Appendix 16

TECHNICAL ASSESSMENT OF DERRYBRIEN WINDFARM AND ANCILLARY WORKS

JULY 2021

Figure 1: Contents of Appendices as listed in the Chapter 10 Main Chapter

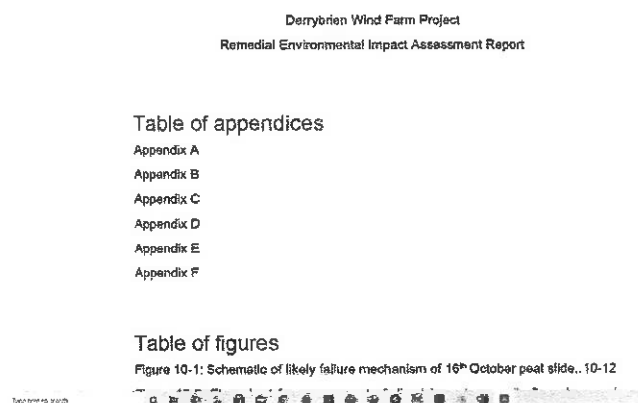
The rEIAS document provides a list of contents for the document itself, but provides no information in the Contents pages about what is contained within the Appendices (see attached Figure).

This provided list of Appendices suggests that there are six Appendices, A – F, but what these contain and what their significance might be is left to the reader to guess. Turning to the Appendix document itself (namely Chapter 10 – Soils, Geology and Land Appendices, Document No.: QS-000280-01-R460-001-000), this provides no Contents page or Index at all, other than the contents pages of the individual reports presented within the appendices – to which there is no guide at the start of the document. Furthermore, it emerges that there are not six Appendices but instead a nested multitude of Appendices, in some cases going down as far as four levels of Appendix.

Figure 1. Smooth face of a peat crack, or fissure, resulting from peat shrinkage caused by water loss from the peat matrix as a result of drainage. The face is aligned along a former forestry ploughing furrow. Photograph taken during a 2004 field investigation of the Derrybrien windfarm site.

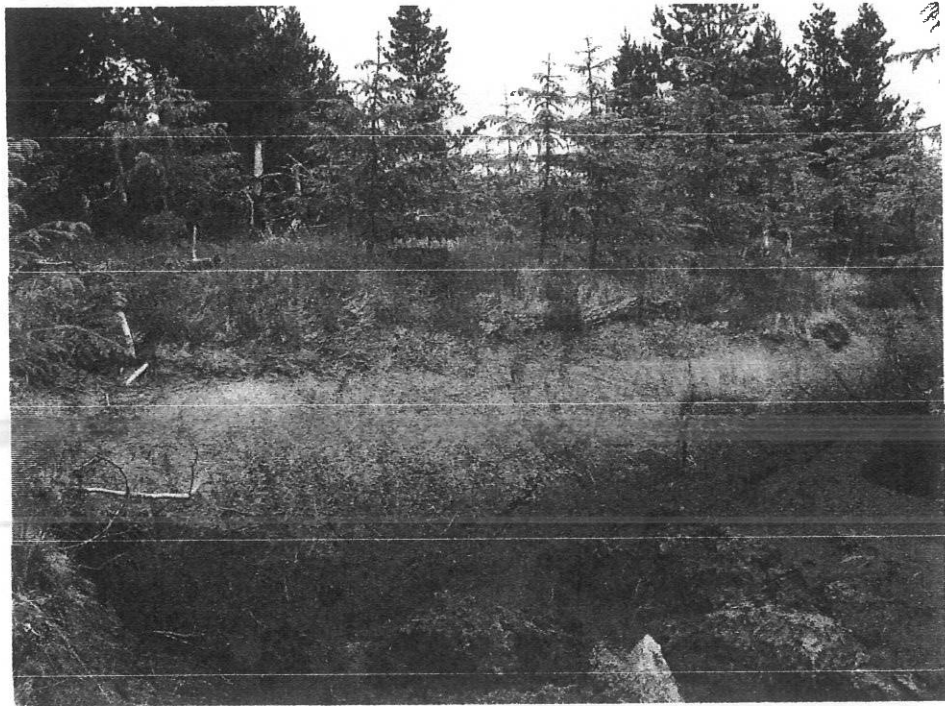
Nor is there a **map indicating location, extent and orientation of cracks, fissures, ridges or other pre-failure indicators**. That such cracks and fissures exist at Derrybrien is highlighted repeatedly by Lindsay & Bragg (2005), who emphasise that cracks can be found extensively throughout the forested areas (see Figure 1).

A key, indeed a critical, part of the Derrybrien rEIAS should therefore have been the mapping of all such cracks and fissure, but the rEIAS makes no mention of such cracking. As SGG-2017 observes: *“In preparing assessments of peat stability, developers should give afforested peatlands (which are often hydrologically disrupted and physically degraded) the same scrutiny as peatlands without forest, even if this may be more arduous in practice (due to concealment of the ground surface by tree cover and associated access difficulties).”*

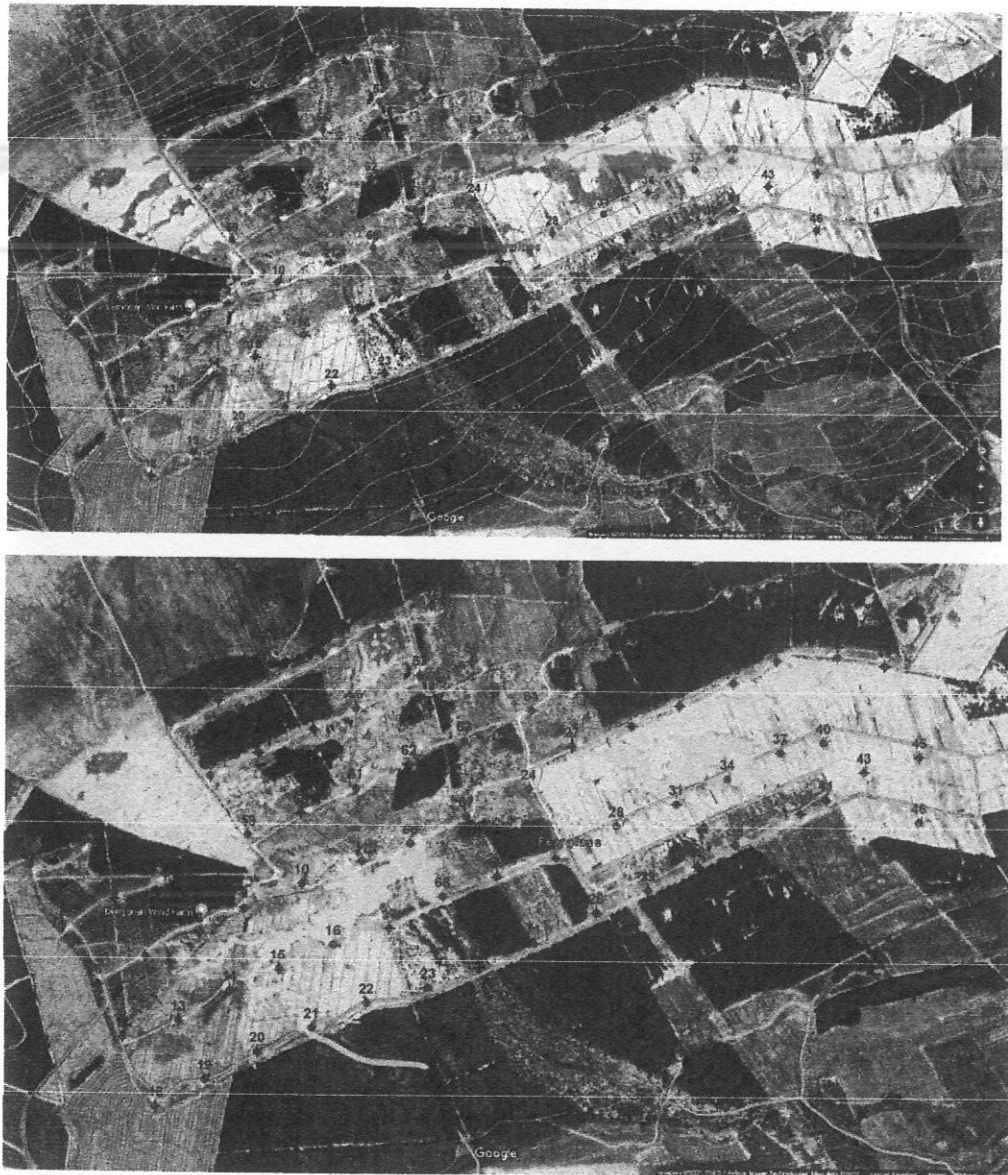
It seems likely that there is further failure in basic mapping of the ground condition in terms of how the information obtainable from aerial photography has been interpreted. With reference to the aerial photographs provided as ‘Figure 10-4 in Section 10.2.1.3’ of the rEIAS and ‘Figure 2-1 of Appendix E’, the latter figure points to a dark sinuous band of colour crossing the turbary area and describes it as ‘*deep peat along subsurface drainage channel*’ which is undoubtedly the case, given the sinuous nature of the dark shading.

A similar band of sinuous shading which forms a huge crescentic shape leading down into the same ‘shallow valley’ which experienced the 2003 peatslide (see Figure 2) is merely identified (along with others) as an ‘*Area of deeper peat and high water table on flat terraces (Darker vegetation)*’ but with no mention of the (very likely) possibility that this, too, is an area of sub-surface piping and/or seepage. Furthermore, the dark zones identified in the NW corner of the aerial photograph and lying just outside the windfarm boundary actually point downslope and converge on a natural drainage line, so it is possible that these, too, are seepage zones or areas of sub-surface piping.

Further areas of dark ground can just be discerned vanishing into the forest blocks within the windfarm site, so it is possible that sub-surface seepage is widespread within the site. These may be natural zones of seepage, but published evidence from, for example, Holden *et al.* (2002) and Holden (2005) have identified a clear linkage between drying peatlands and prevalence of sub-surface piping.

It should also be noted that the heads of the pale blue seepage zones in Figure 2 all begin along the line from Turbines 27 to Turbine 42.

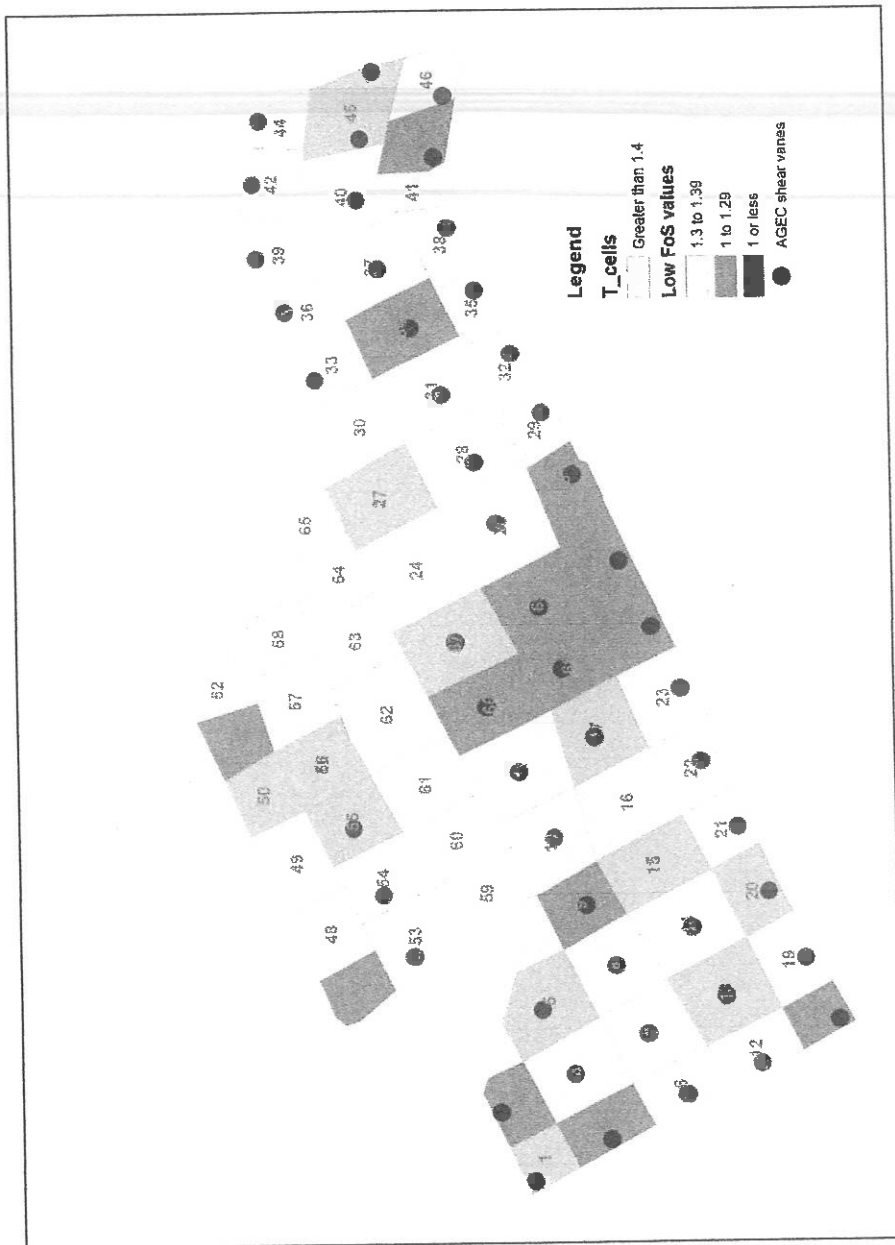
Secondly, the FoS calculation for each T-cell was based on testing the peat in only a single location in each T-cell, and even this in only a proportion of the full set of T-cells (see Figure 6).

The risk assessment offered in ‘rEIAS, Section 10.2.4.4 and Figures 10-34, 10-35, 10-36’ is thus based on a synthesis of the data gathered some 16 years ago in 2004/5 across only parts of the site and is essentially a re-working of this information into a risk assessment.

Figure 8. Peat Stability Assessment by AGL (2020) for baseline conditions in 1998 for each T-cell. Highest risk rating is '5'. Note the concentration of high risk cells in the northern section of the site, and also the high risk value along the western margin of the site.

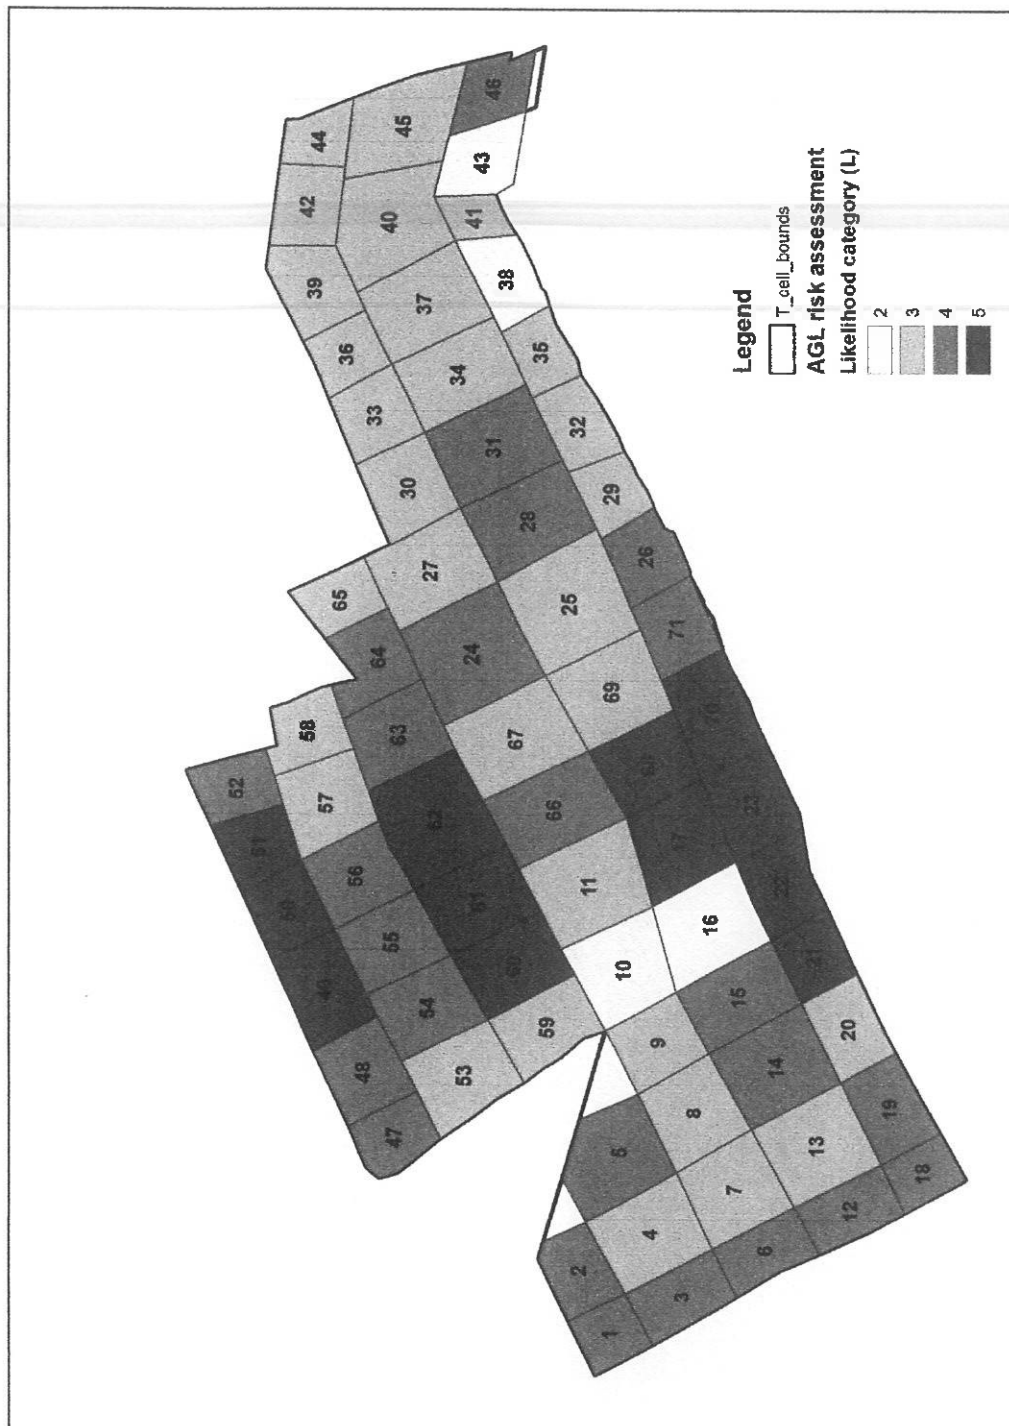
significant risk of instability and consequent impact (see Figure 8). The distribution of shear vane tests in relation to this assessment can be seen in Figure 9, while correspondence with the original 'worst-case' map generated by AGECE (2004) can be seen in Figure 10.

What is most striking about the areas identified as being at risk in by AGECE (2020) is the clear concentration of T-cells at risk in the northern sector of the site, mirroring the already-failed area of the 2003 slide to the south. This region remained largely un-surveyed by AGECE (2004) so the main records for peat condition come from ESBI (2005). Even after this survey, however, some critical T-cells remain largely un-tested, as can be seen from Figure 9. They still emerge as being significantly at risk because of other risk factors. Concentration of high-risk areas in the northern and western parts of the site is reinforced by the findings of the AGECE (2004) report, as can be seen in Figure 10.

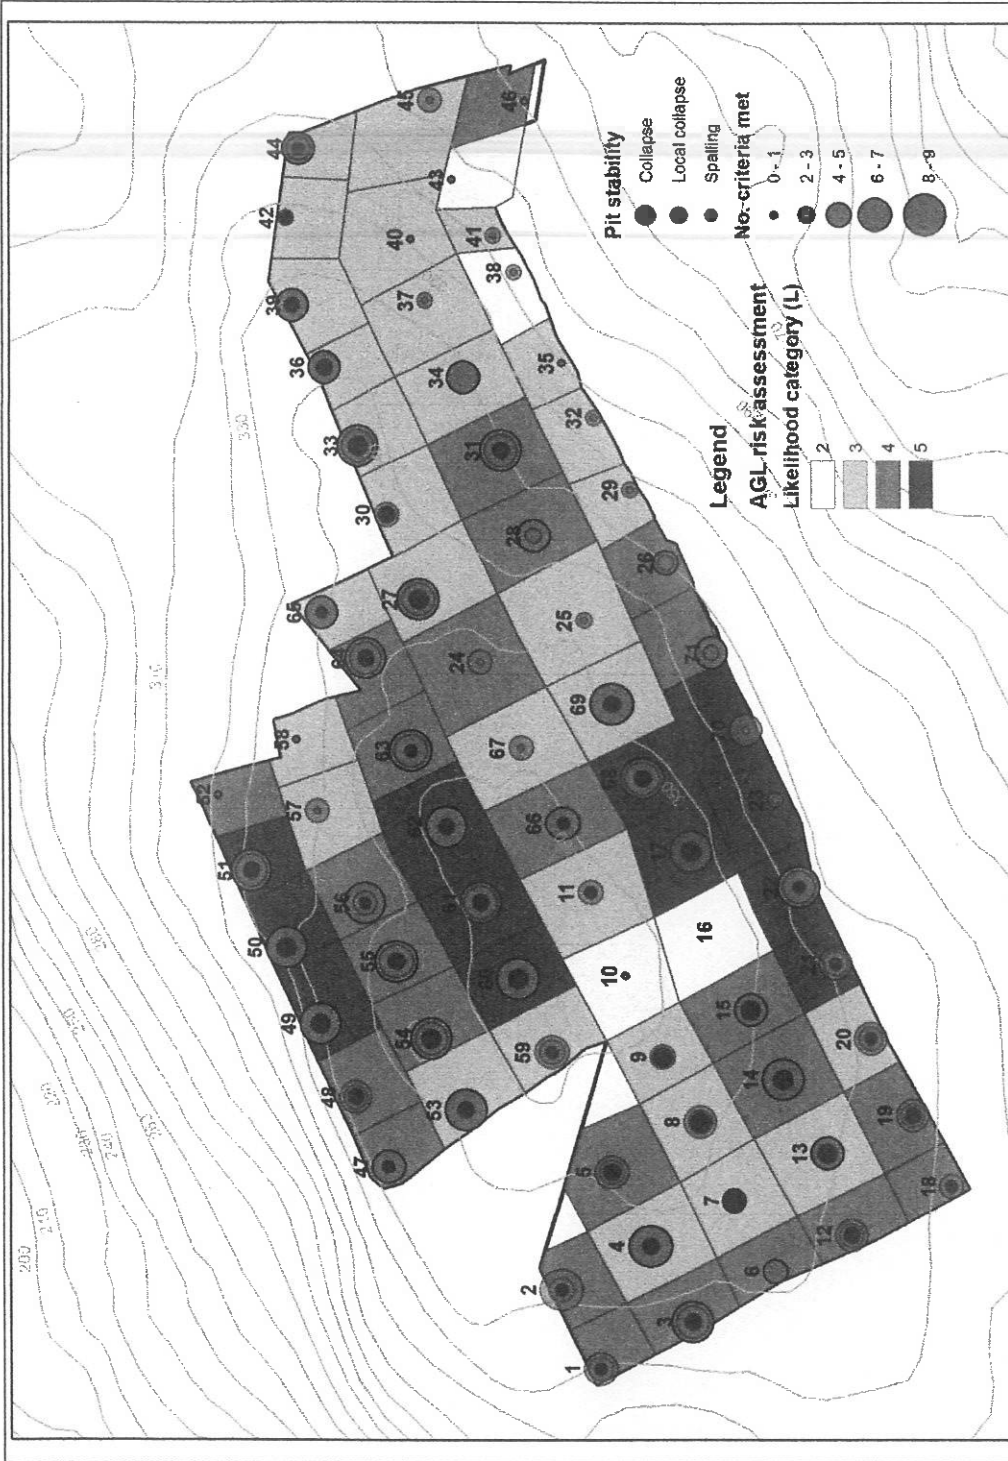
Figure 11 compares the distribution of T-cells at risk based on the data in Table 3 with the distribution of at-risk T-cells presented by the rEIAS (and shown in Figure 8 above). From this it can be seen that there is good correspondence across all those T-cells identified in the rEIAS, but the revised assessment based on the data in Table 3 highlights a number of additional T-cells.
